Access Compliance Report

Public Rights-of-Way

Intersection ID: 52893	Main Street: TWITTER_LN	Cross Street: SANCTUARY_PL	Location: NW
ADA ID: 964ADC4C9678	Ramp Type: Perp	Initial Pass/Fail: Fail	Overall Compliance: No
		Severity Score: 22.5

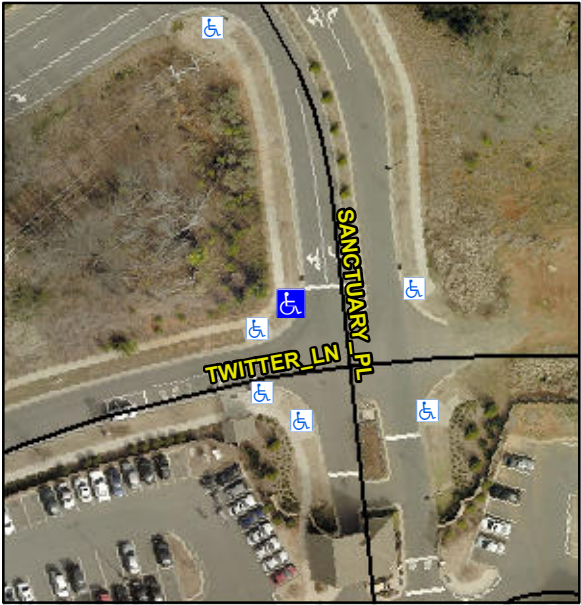
Codes/Mitigation Info/Possible Solution			Field Measurements/Component Compliance		
	Possible Solutions:		Compliance	Description	Data
	Remove & Replace Entire Ramp.		No	Ramp Length (in)	97.0
			No	Ramp Width (in)	46.0
			N/A	Flare Type LT	N/A
			N/A	Flare Slope LT (%)	N/A
			N/A	Flare Traversable LT?	N/A
			N/A	Landing Length (in)	N/A
			N/A	Landing Width (in)	N/A
			N/A	Landing Slope (%)	N/A
			N/A	Landing X Slope (%)	N/A
<p>Surveyor Notes:</p> <p>N/A</p> <p>PROW/ADA:</p> <p>Not Found, R304.5.1, R304.2.2, R304.5.3</p>			N/A	Flare Type RT	N/A
			N/A	Flare Slope RT (%)	N/A
			N/A	Flare Traversable RT?	N/A
			N/A	DWS Provided?	N/A
			N/A	DWS Contrast?	N/A
			N/A	DWS Length (in)	N/A
			N/A	DWS Full Width?	N/A
			N/A	DWS Offset (in)	N/A
			N/A	Shared Landing?	N/A
			N/A	Gutter Ponding?	N/A
			N/A	Gutter Lip Ht (in)	N/A
			N/A	Painted X Walk1?	No
				X Walk 1 Direction	To E
			N/A	X Walk 1 Width (in)	N/A
				X Walk 1 Slope (%)	1.3

X Walk 1 X Slope (%)	3.9
			N/A	Ramp inside XWalk1?	N/A
			N/A	Ramp inside XWalk2?	N/A
			N/A	Road Slope (%)	N/A
			N/A	Road X Slope (%)	N/A
			N/A	Any Obstructions?	N/A
				Obstruction Type	
			N/A	Clear Space?	N/A
			N/A	Clear Space to XWalk (in)	N/A
			N/A	Storm Grate/Utility Hazard?	N/A
				Storm Grate/Utility Type	
			N/A		N/A
			Yes	Surface Condition? (G/P)	Good
